Re: Petition 1458 - Responses to CSC Interrogatories (Set 1)

Homestead Fuel Cell 1, LLC

Petition No. 1458

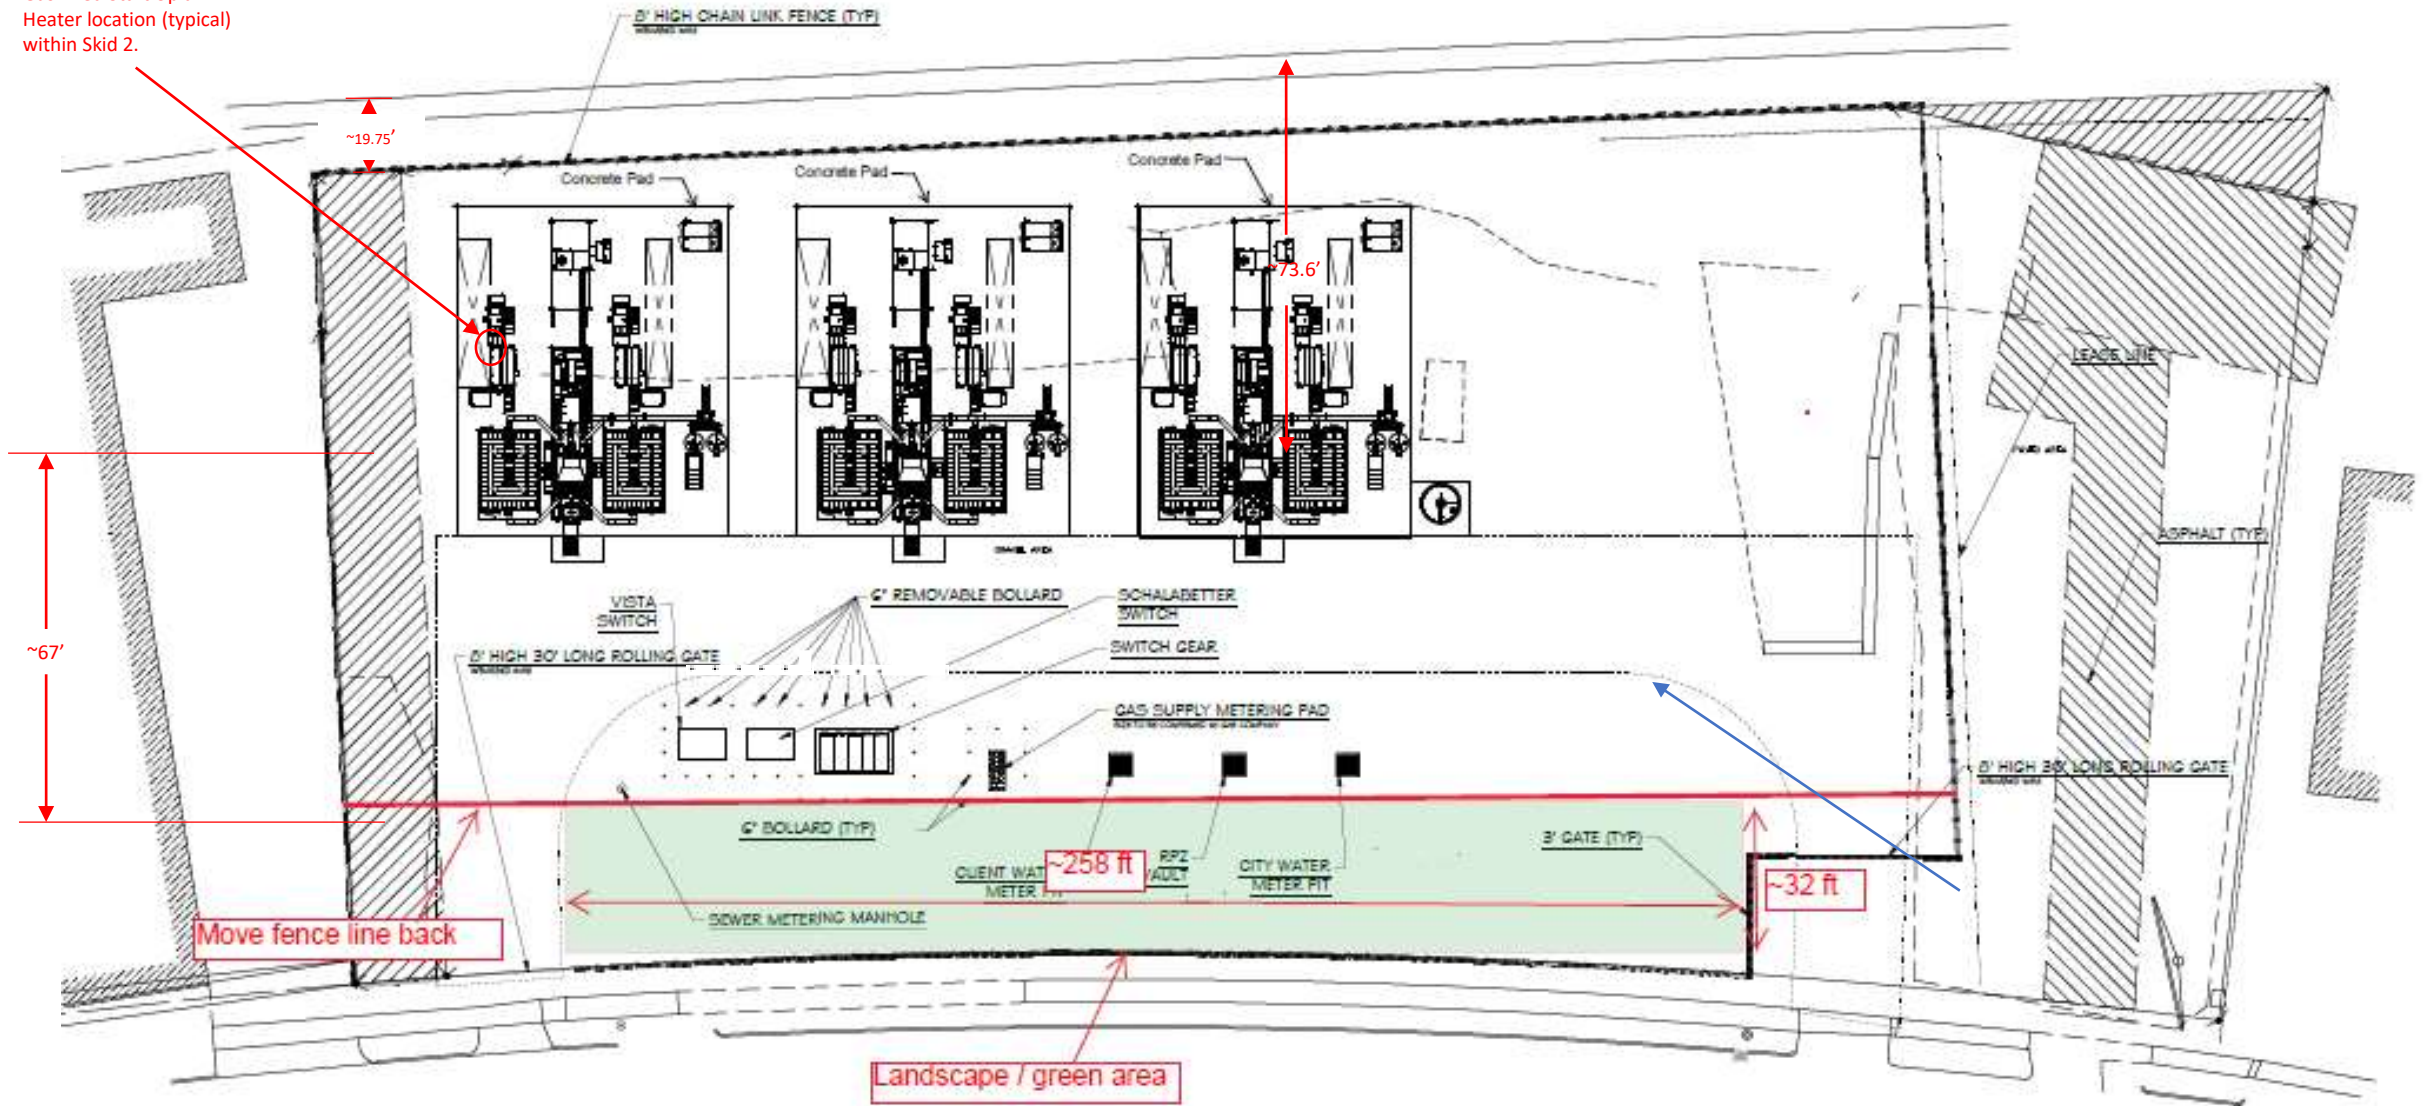
Q-CSC-5: Does the underground interconnection plan involve going under the Amtrak railroad tracks? If so, what permits are required from state and federal agencies? If so, please describe the construction method to be employed.

A-CSC-5: No, at this time the proposed connection path will go above-ground and along the street as shown in the figure below:

EXHIBIT CSC-10

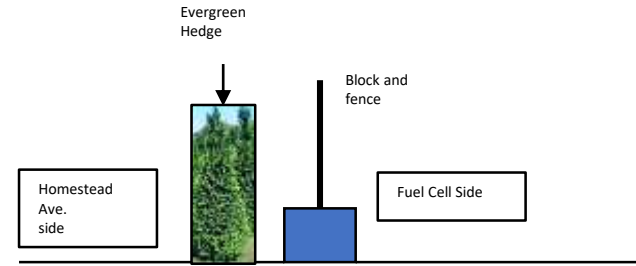
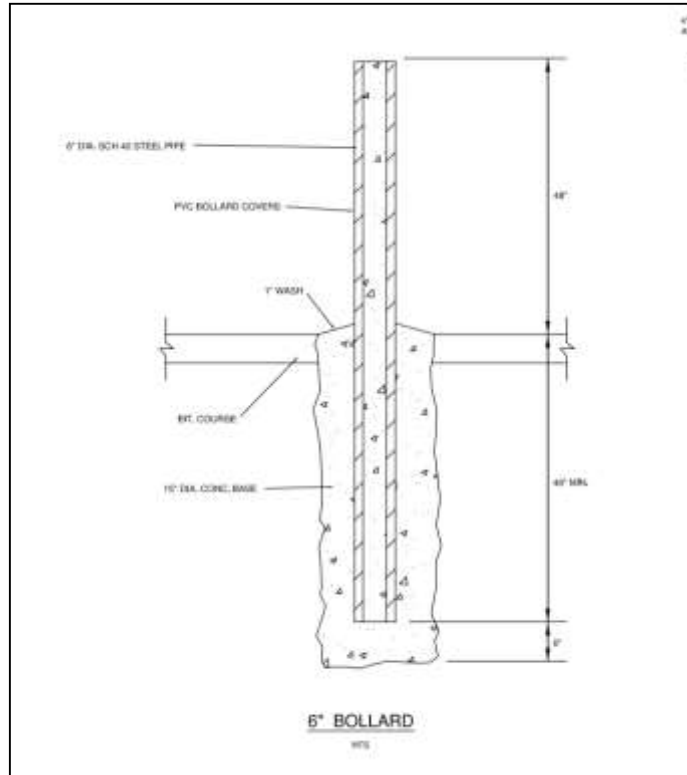
Q-CSC-10: Referencing the Exhibit A Site Plan, will bollards surround the switch, switch gear and gas supply metering pad on all sides? What appear to be bollards seem to have been cut off or eliminated due to the movement of the fence line (depicted as a bold red line). Please explain.

A-CSC-10: Bollards will surround the switch, switch gear and gas supply metering pad on all sides. Please see Exhibit CSC-10.

A-CSC-20: Please see the updated site plan in CSC-10 above.
